**Response to Environmental Statement
submitted in relation to
Berden Hall Solar Farm
(Pelham Solar)**

PINS Reference:

S62A/22/0006

14 February 2023

Figure 1: map showing location of existing and Proposed Developments in Berden, Stoking Pelham and surrounding area

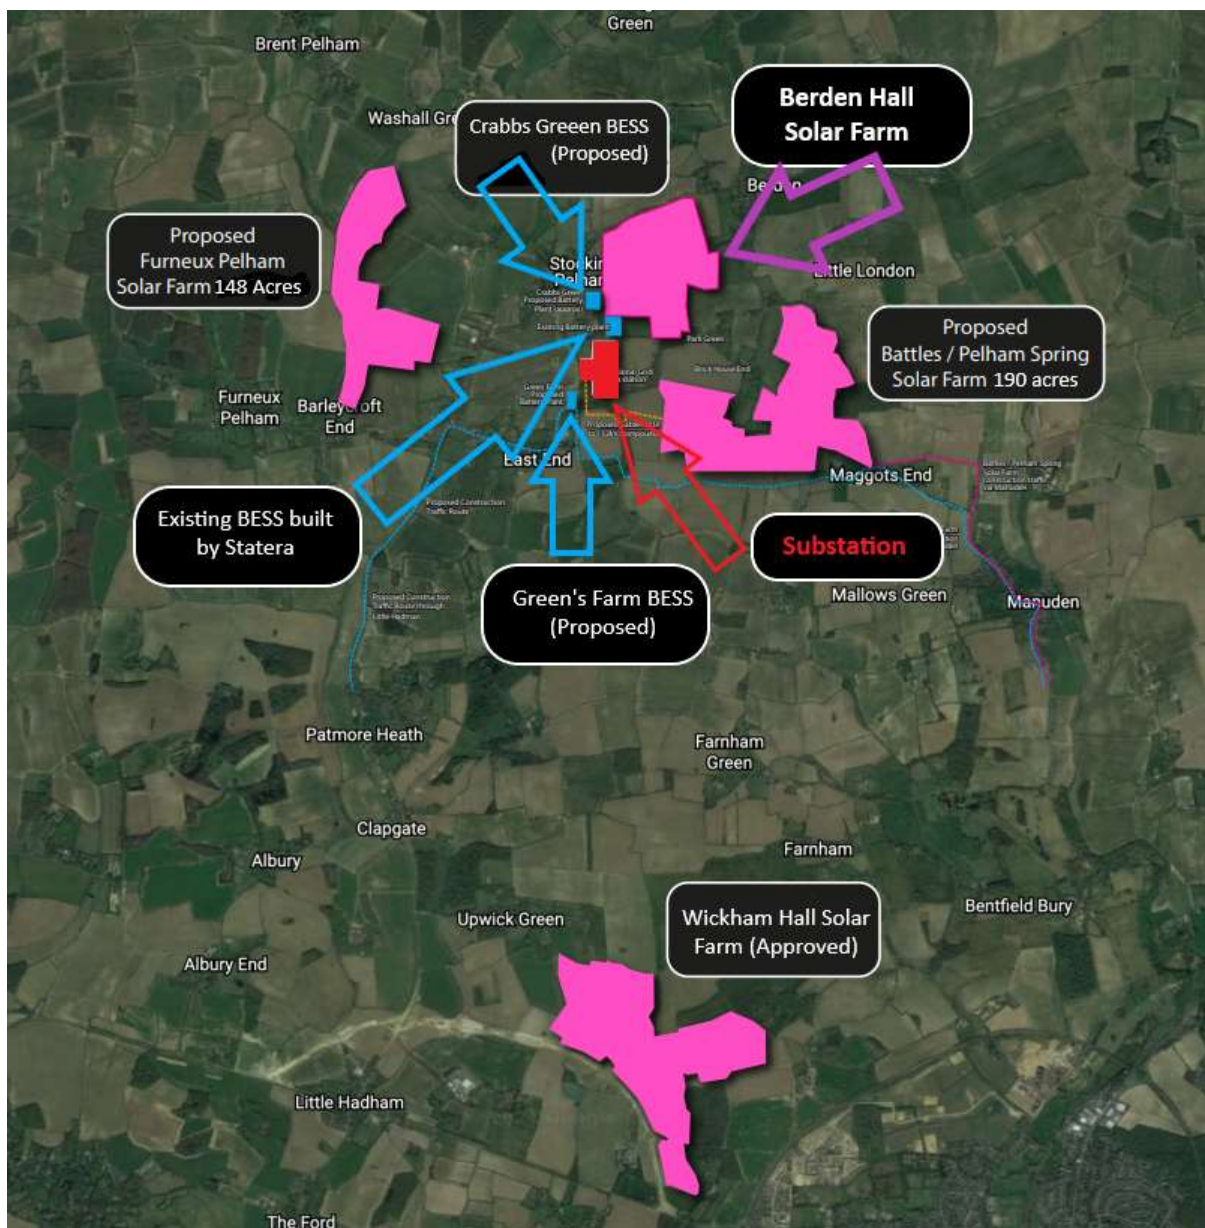
22. It is extraordinary that the Applicant **has failed to give any consideration to the cumulative effects** of the following sites which are in close proximity to the Proposed Development:

- the existing National Grid substation at Stocking Pelham;
- the **existing Battery Energy Storage System constructed by the Applicant** (application numbers UTT/16/2316/FUL and UTT/17/2075/FUL) **which is immediately adjacent to the site of the Proposed Development;** and
- an application for yet another Battery Energy Storage System at Green’s Farm (East Herts DC 3/21/0969/FUL) which was submitted before the application for Stocking Pelham Battery Energy Storage System referred to above; and
- a 35 MW solar farm on 146 acres of land at Wickham Hall (East Herts DC 3/21/2601/FUL) which was approved for construction in January 2023.

25. The map below illustrates all of the sites in close proximity to the site of the current application which should have been considered by the Applicant for the purposes of the CEA:

Figure 3: map showing location of the Proposed Development and “Pelham Spring Solar Farm” (proposed)

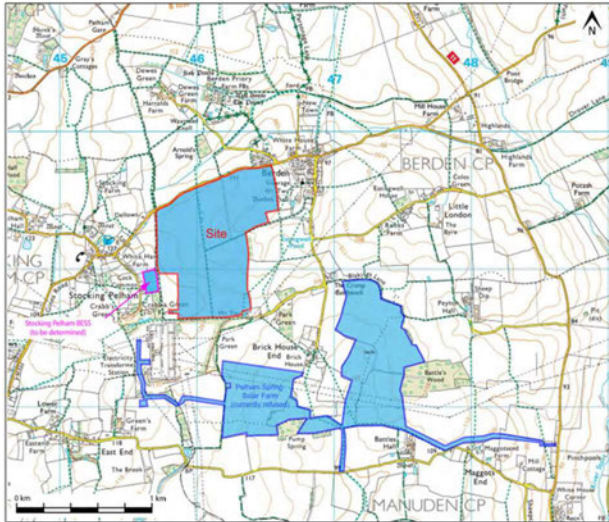
29. Notwithstanding the assertion that there is no requirement to consider the cumulative impact of “Berden Hall Solar Farm and “Pelham Spring Solar Farm”, the Applicant has undertaken some superficial analysis of potential effects. The map provided by the Applicant (at Figure 5.9 and set out below) shows the location of both its Proposed Development and the location of “Pelham Spring Solar Farm”

32. This conclusion is not credible. The Applicant fails to point out that Brick House End is on a slope which rises up to The Crump. On arrival at The Crump, users of the lane (which include horse riders, dog walkers and cyclists – in particular parents with young children) will be ideally placed to look down on “Berden Hall Solar Farm” (to their right) and need only turn their heads to the left to look up to Pelham Spring Solar Farm which is to be located prominently on the sloping land below Battles Wood (an ancient woodland).
